SERVICE BULLETIN NO.: NMD-28-20

TITLE: Fuel - Auxiliary Tank - Strengthened Pipe Assembly (Modification N681)

FUEL - AUXILIARY TANK - STRENGTHENED
PIPE ASSEMBLY
(MODIFICATION N681)

Pipe Assemblies, Location and Installation
Figure 1

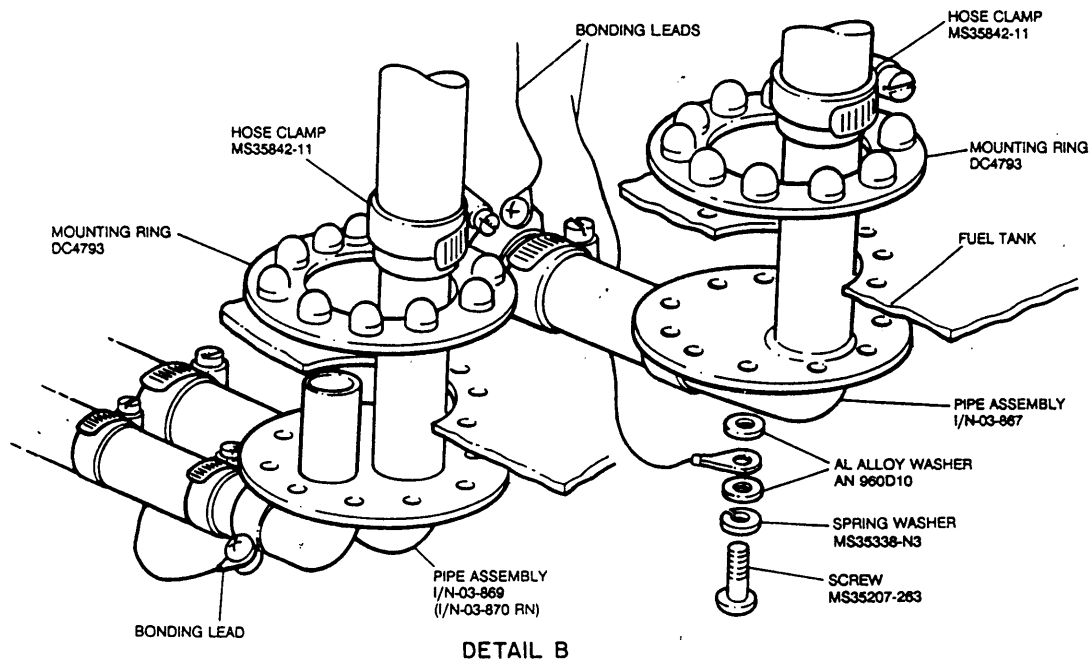
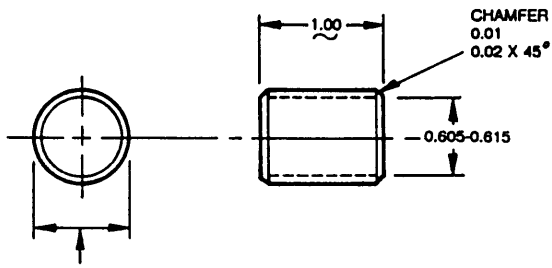
- G. Loosen the hose clamps attaching the rubber hoses to pipe assembly 1/N-57-250, refer Figure 1. Remove the bonding lead and remaining screws securing the pipe assembly to the mounting ring. Remove the pipe assembly.

- H. Loosen the hose clamps attaching the rubber hoses to pipe assembly 1/N-57-251 (1/N-57-252 RH), refer Figure 1. Remove the screw securing the bonding lead to the clamp. Remove the screws securing the pipe assembly to the mounting ring and remove the pipe assembly.

- M. Fit bushes into respective pipes and secure in position with Loctite 635 or similar.
- N. Position pipe assemblies and push rubber hoses onto pipes, do not tighten hose clamps. Secure pipe assemblies in position with screws and mounting rings, fitting bonding leads as shown in Figure 1. Check that rubber hoses are fitting correctly and tighten hose clamps.

- S. Remove the wing trestle.
- T. Fuel tanks sufficiently to allow hose connections to be checked, refer MM 12-10-00.
- U. Gain access to the pipe connections at the inbound end of the auxiliary tank and check the blanking plug and hose on the redundant vent pipe for leaks, refer Figure 1 Detail A.

Details of Pipe Assemblies and Bushes
Figure 2

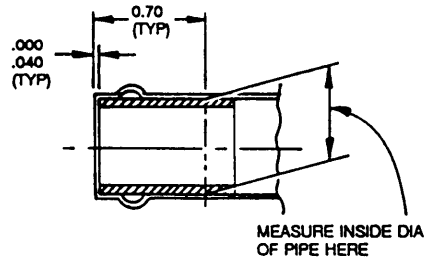
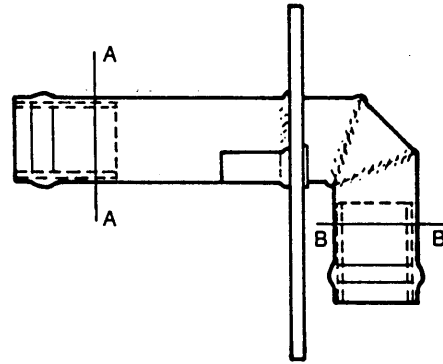
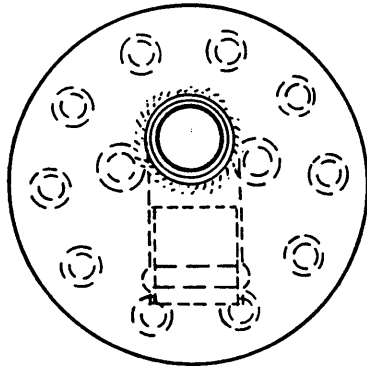
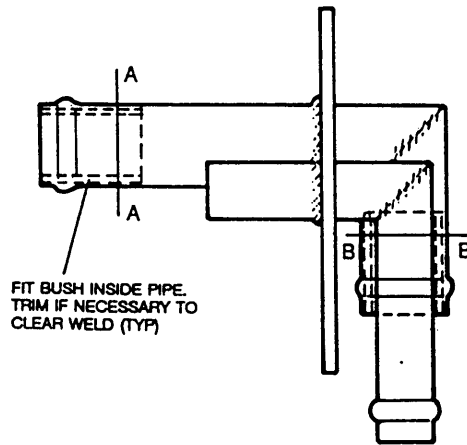
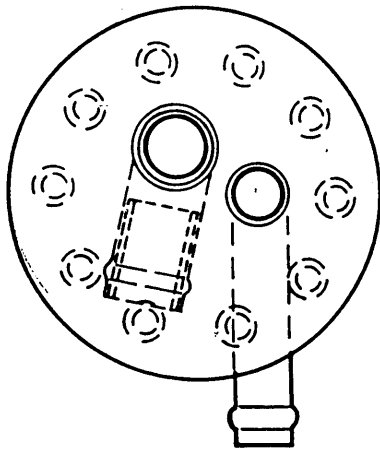
- K. Measure the inside diameter of the pipe assemblies as shown in Figure 2 (4 places).
- L. Referring to Figure 2 Details of Re-inforcing Bushes, turn-up four bushes from .75 in dia aluminium bar QQ-A-225/6 T851 to suit individual measurements taken in K. above.

ALLOW .002 - .010 CLEARANCE ON INSIDE
DIMENSION MEASURED AT SECTION A-A AND B-B

PART NUMBER I/N-03-867
(REWORKED FROM I/N-57-250)

PART NUMBER LH I/N-03-869 (REWORKED FROM I/N-57-251)
RH I/N-03-870 (REWORKED FROM I/N-57-252)
